PLANNING, ZONING, & BUILDING DEPARTMENT
PZ&B Staff Combination Memorandum: Architectural Commission and Town Council

SUBJECT: ARC-24-008 (ZON-24-047) 264 DUNBAR RD (COMBO)

MEETING: MARCH 27, 2024
APRIL 10, 2024

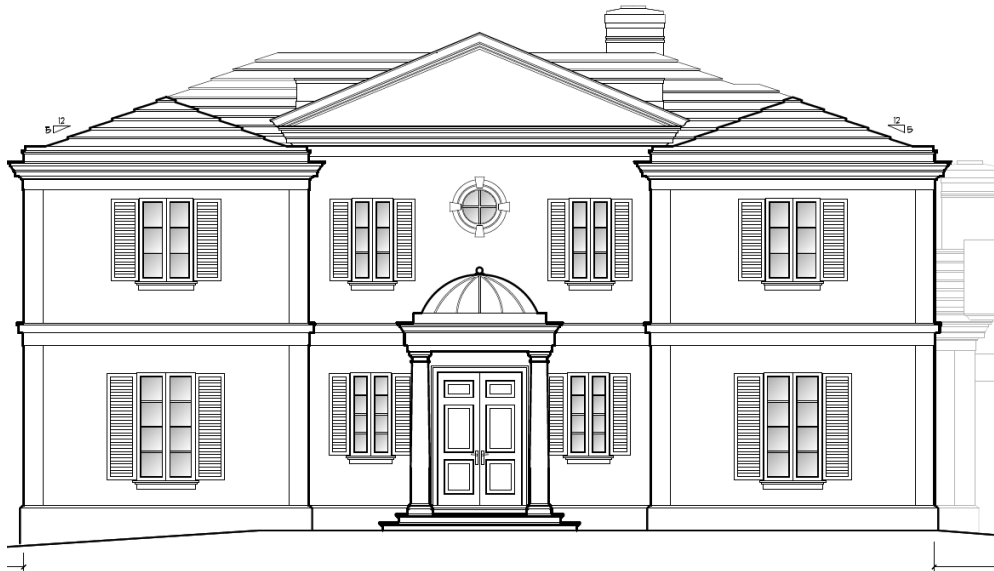
- **VARIANCE 1:** [Sec. 134-1669](#): A variance for an equipment screening wall height of 8.25' in lieu of the 7' maximum permitted.

Currently Proposed North Elevation

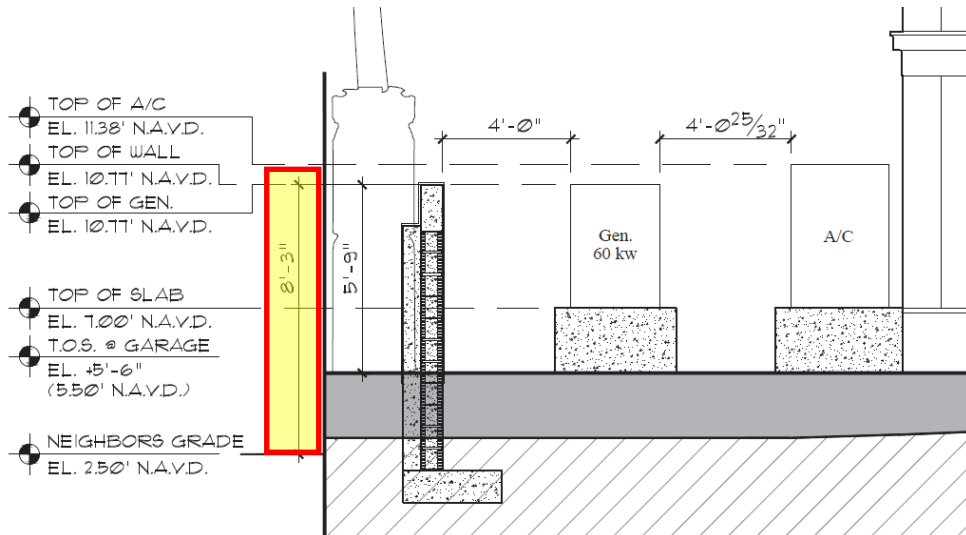
The applicant has resubmitted plans in response to comments of the architectural commission. The front façade was adjusted by removing the domed entry portico and replacing it with a portico featuring a Palladian window with railing above. Quoins have been incorporated onto the building. The second floor guest suite proposed above the garage has been relocated to the first floor behind the garage, eliminating a second story above the garage. The size and direction of the pool has been modified. The balcony at the primary suite has been reduced and the balcony at the west guest bedroom has been completely eliminated and replaced with a window.
